Date: 06.02.2015
 Your Ref:
 Our Ref: L-STL2926D-SD-002

Re: 95 Hillway, Highgate, London

Following receipt of recent comments from the Holly Lodge Estate Committee via LBC Planning Department, we would like to offer the following response.

Title	Scale	Drawing number
Plan showing existing site features, approximate footprint of proposed basement and location of exploratory positions	1:125 @ A3	02rev1

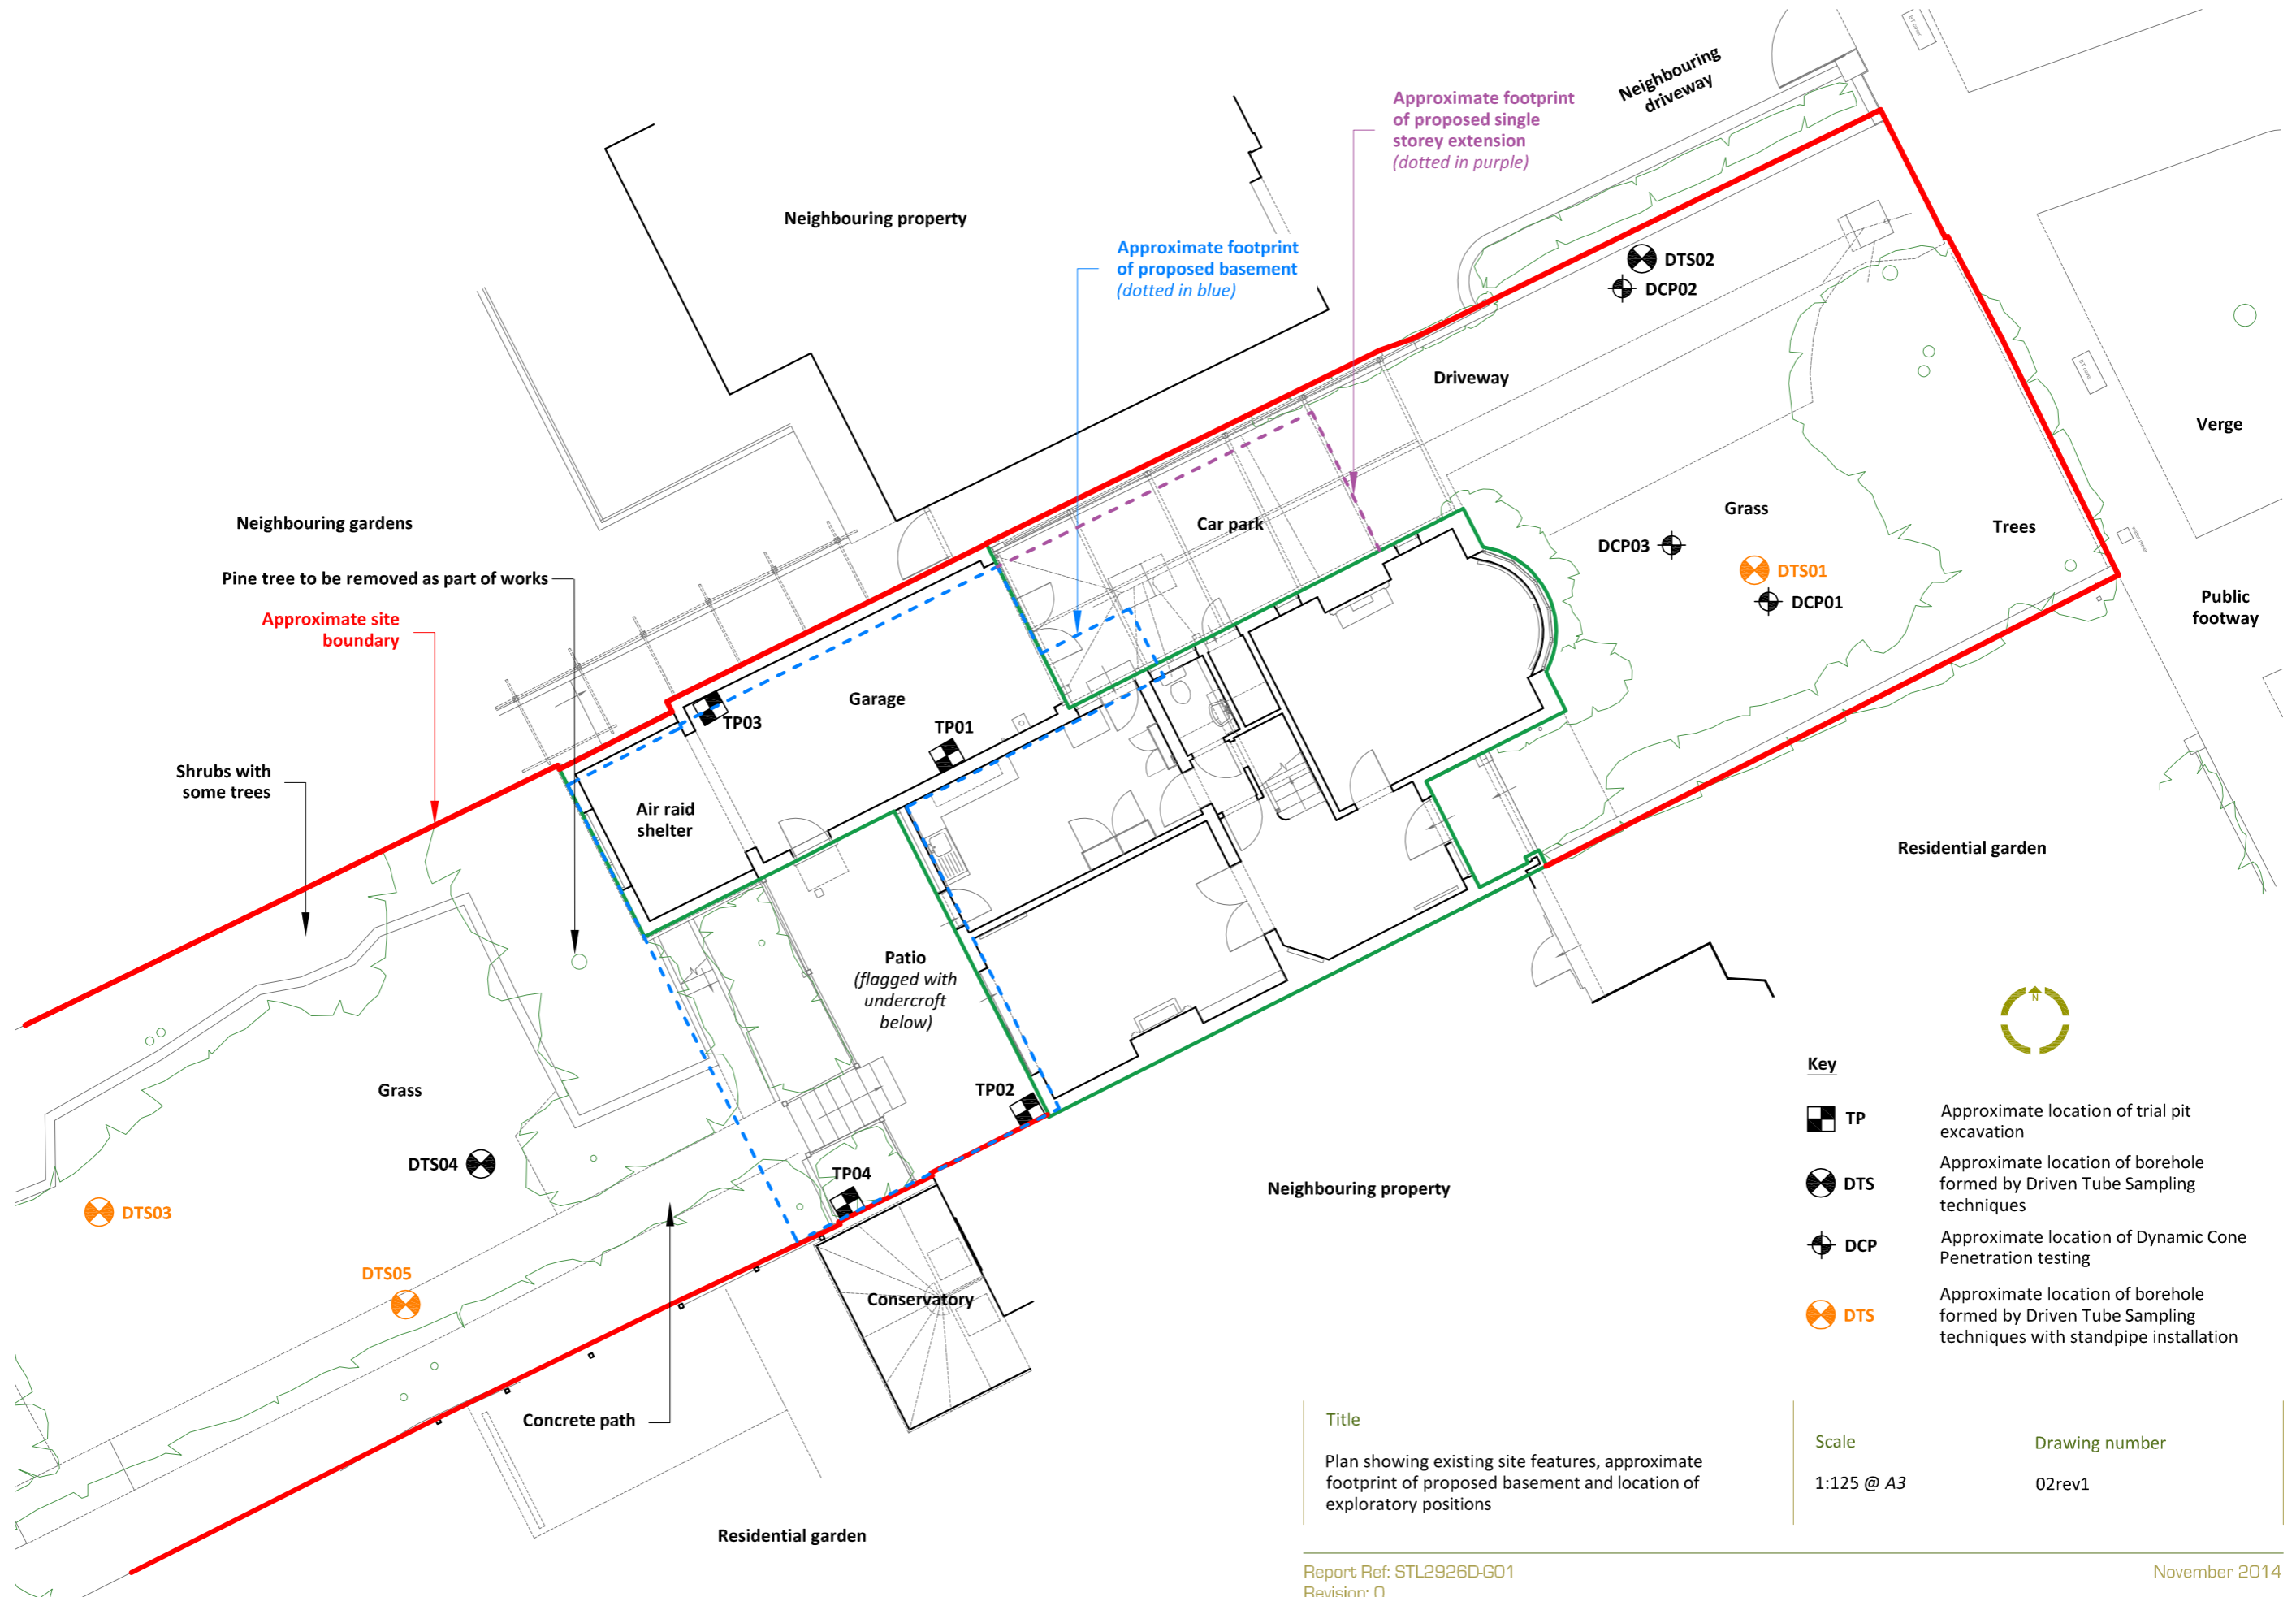
We understand the lane to the rear of 95 Hillway, running from Holly Lodge Gardens to Robin Grove is a former carriageway cutting which is subject to surface water flow with a spring being present within the lane. The lane is approximately 2m below the rear garden level of 95 Hillway. Ground levels across the footprint of 95 Hillway vary by approximately 2.73m from front to back (ref attached topographical survey).

Ground water monitoring has been undertaken at the site and the table below summarises the groundwater levels (to mAOD) in comparison to the proposed formation depth of the new basement.

In view of the above, groundwater levels were recorded to be in excess of 1m below the proposed basement formation depth and thus construction of the basement is not considered to present a 'dam' in the groundwater flow, with formation located above the groundwater table. In addition, ground conditions to the rear of the property, in the location of the proposed basement, comprised predominantly sands which are considered to be permeable (as demonstrated by soil infiltration testing within the unsaturated zone). Formation of the basement and foundations for 95 Hillway will therefore be located on predominantly sand deposits rather than clay, as suggested.

Based on the data obtained to date and in consideration of the spring, cutting, groundwater levels and development proposals at 95 Hillway, the proposed basement will be constructed above the existing groundwater table and thus will not present a 'dam' or diversion and will not impact the localised groundwater flow direction.
